Town of Groveland
Economic Development
Planning & Conservation Department
Planning Board
183 Main Street
Groveland, MA 01834

Board/Committee Name: **PLANNING BOARD**
Date: **TUESDAY, November 19, 2024**
Time of Meeting: **7:00 PM**
Location: **Town Hall 183 Main Street
Groveland, MA 01834**
Signature: *Annie Schindler*

CONTINUED 181R SCHOOL STREET:

A hearing in accordance with M.G.L. Chapter 41, Section 81T, the Town of Groveland Subdivision Rules and Regulations and Article 14 of the Groveland General Bylaws, to hear the application of Groveland Redevelopment LLC. c/o Louis Minicucci Jr, 231 Sutton St, Suite 1B, North Andover MA 01845, requesting approval of a six (6) lot Definitive Subdivision Plan labeled 181R School Street, Groveland, Massachusetts and associated Stormwater Management & Land Disturbance Permit. The site is located in the Residential 2 (R-2) Zoning District. The proposed subdivision is located at 181R School Street Groveland, MA 01834. (Assessors Map 34, Parcel 13).

DATE _____

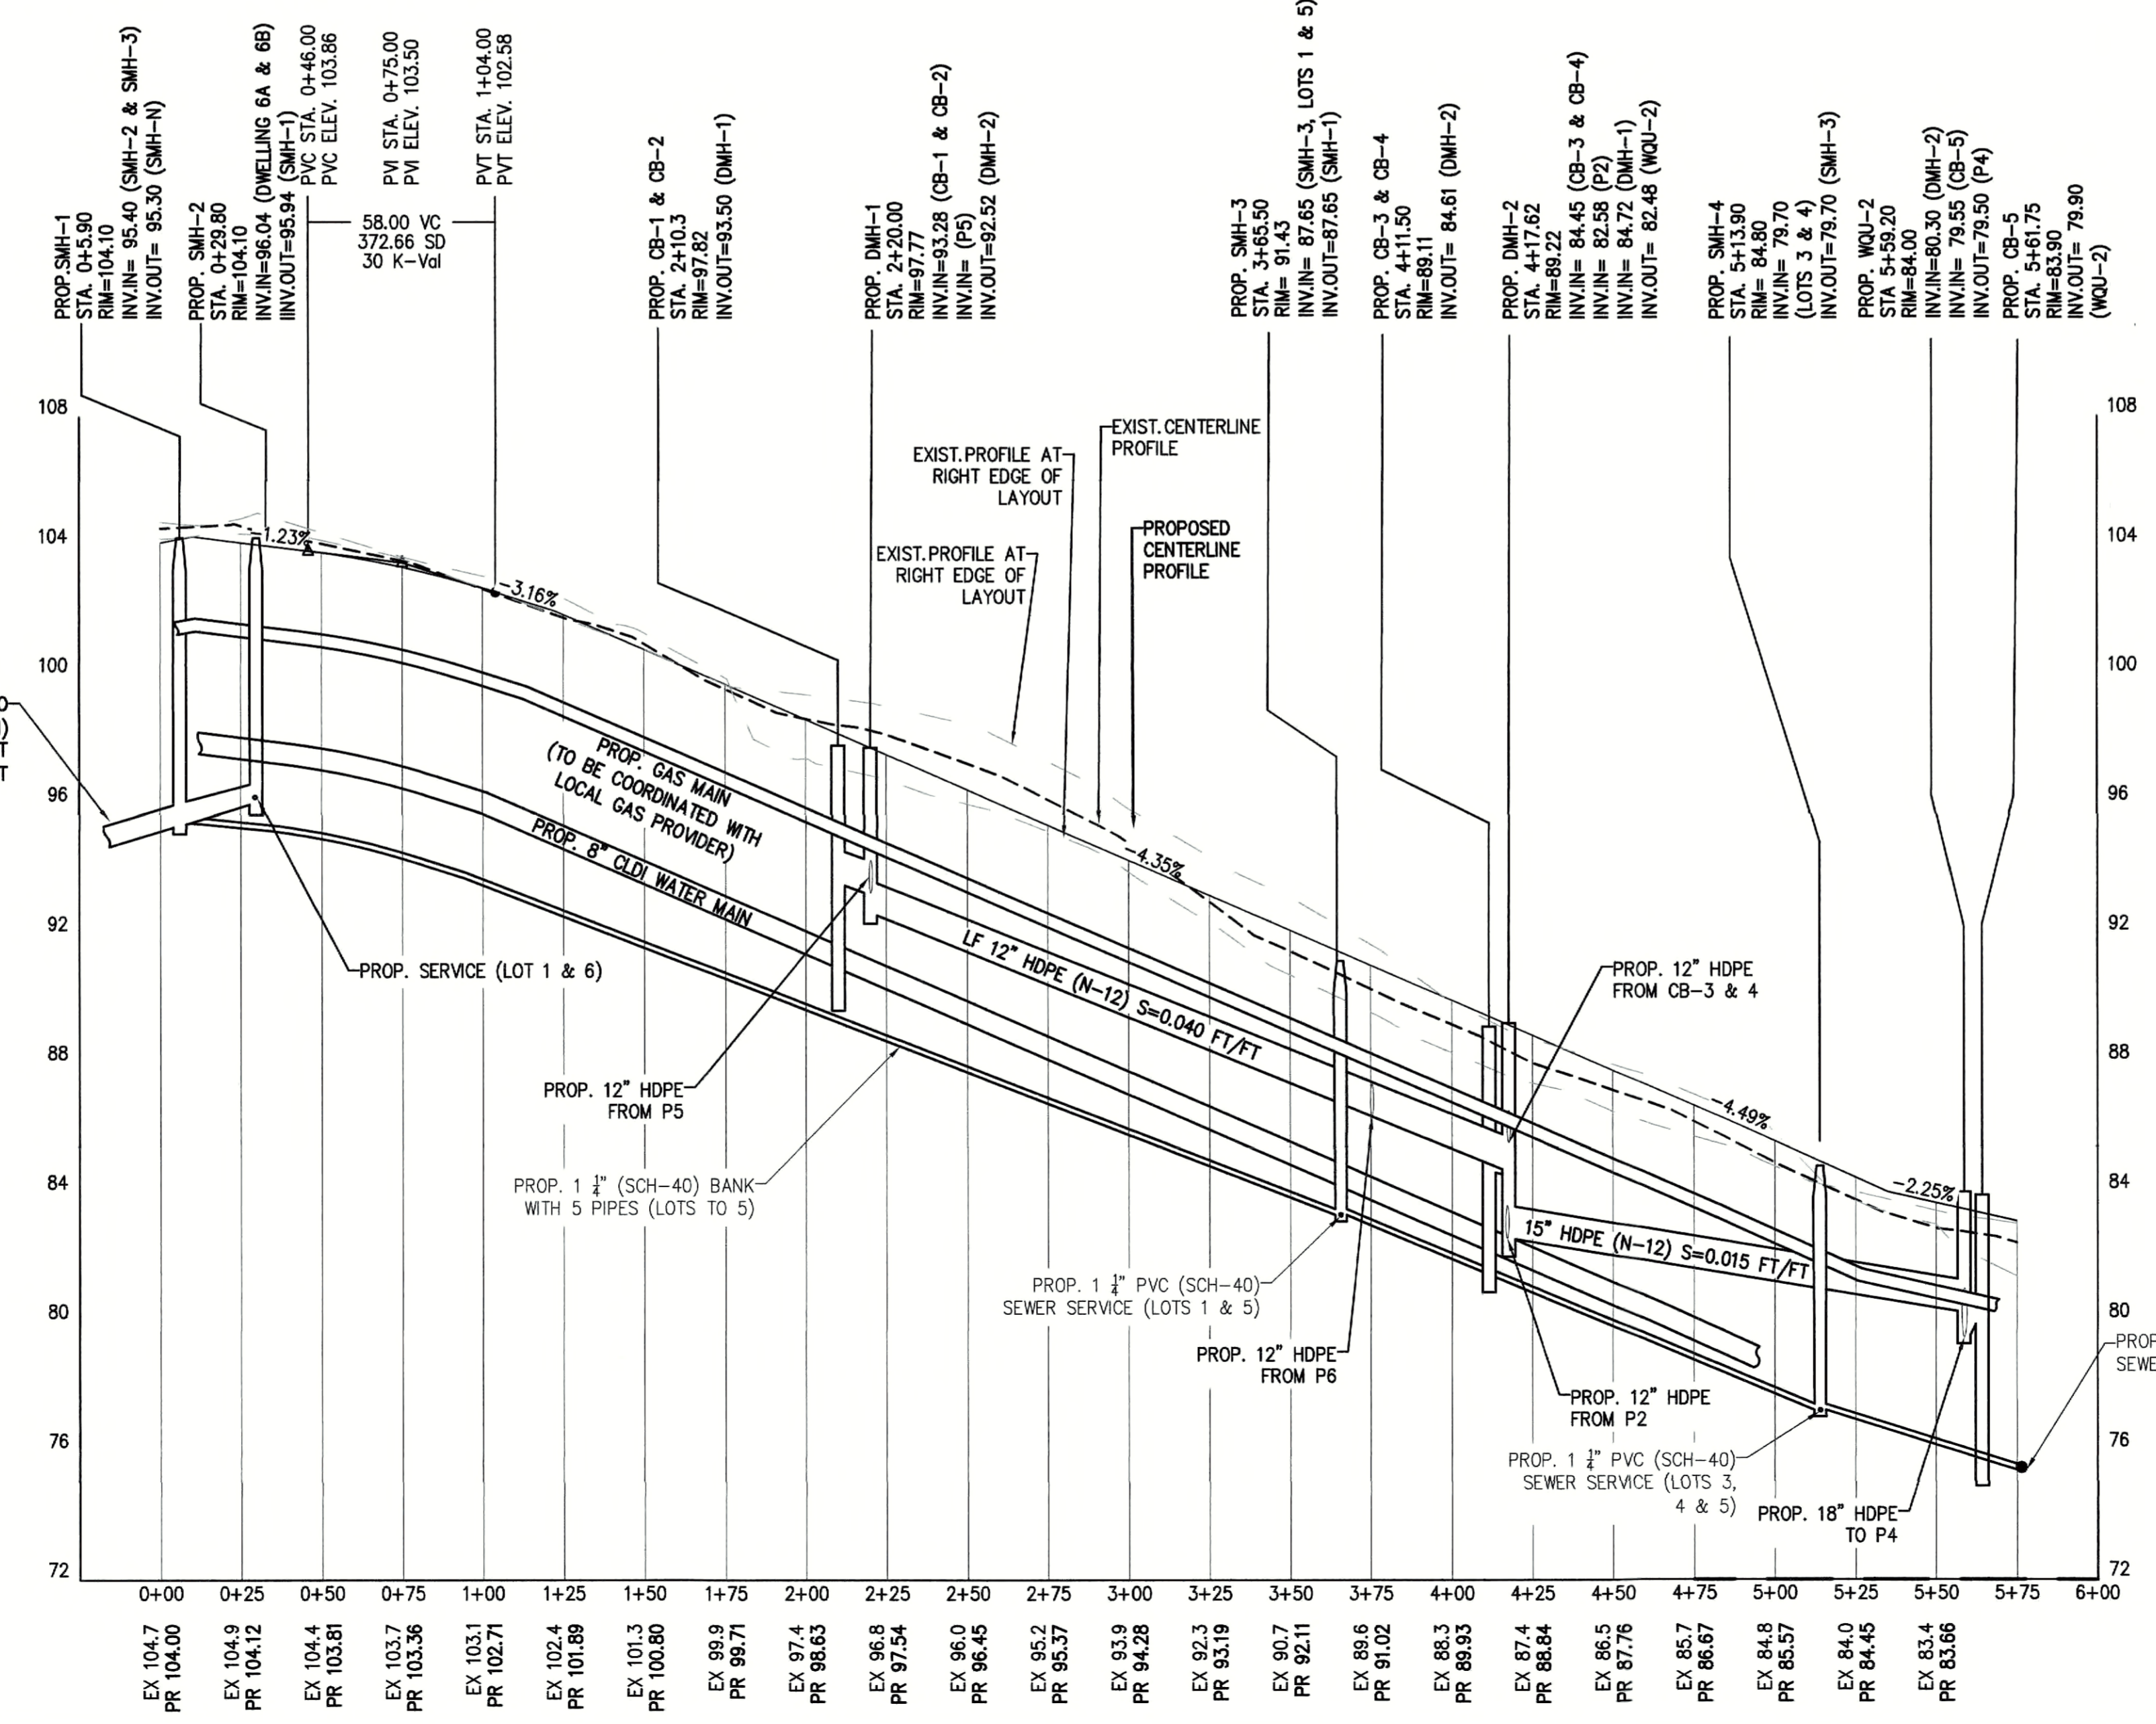
- d. *On Sheet C-7, there is no label detailing the proposed rim or invert elevation(s) for proposed catch basin 2 (CB-2).*

- e. *On Sheet C-7, water quality unit 2 (WQU-2) appears to have pipe inverts leaving the structure that are higher than the inverts in.*

24. **TEC Comment:** *No rim elevation is provided for SMH-1.*
MCG Response: The profile has been updated to include rim and inverts elevation for SMH-1. See Sheet C-7.

25. **TEC Comment:** *Pipe sizing and proposed material type should be provided for the proposed sewer connection from Lot 6.*
MCG Response: The plan has been revised to include the pipe size and material for lot 6. See Sheet C-7.

26. **TEC Comment:** *Two utility conflicts can be observed on Sheet C-7:*
 - a. *SMH-3 appears to be in the middle of the proposed drainage line connection, between Rain Garden P5 and DMH-1.*

- e. On Sheet C-7, water quality unit 2 (WQU-2) appears to have pipe inverts leaving the structure that are higher than the inverts in.

26. Two utility conflicts can be observed on Sheet C-7:

- a. SMH-3 appears to be in the middle of the proposed drainage line connection, between Rain Garden P5 and DMH-1.
 - b. The forced main connection between SMH-4 and the Lot 2 dwelling appears to conflict with the drainage line between DMH-2 and WQU-2.
- a. **MCG Response: The plan has been updated to move SMH-3 away from P5 and DMH-I. See Sheet C-7.**
- b. **MCG Response: The proposed force main connection crosses under the drain line, but a vertical separation of 1.5 ft.**

MCG Response: The plan has been updated to move SMH-3 away from P5 and DMH-1. See Sheet C-7.

MCG Response: The profile has been updated to include rim and inverts elevation for SMH-1 . see Sheet C-7.

MCG Response: The plan has been revised to include the pipe size and material for lot 6. See Sheet C-7.
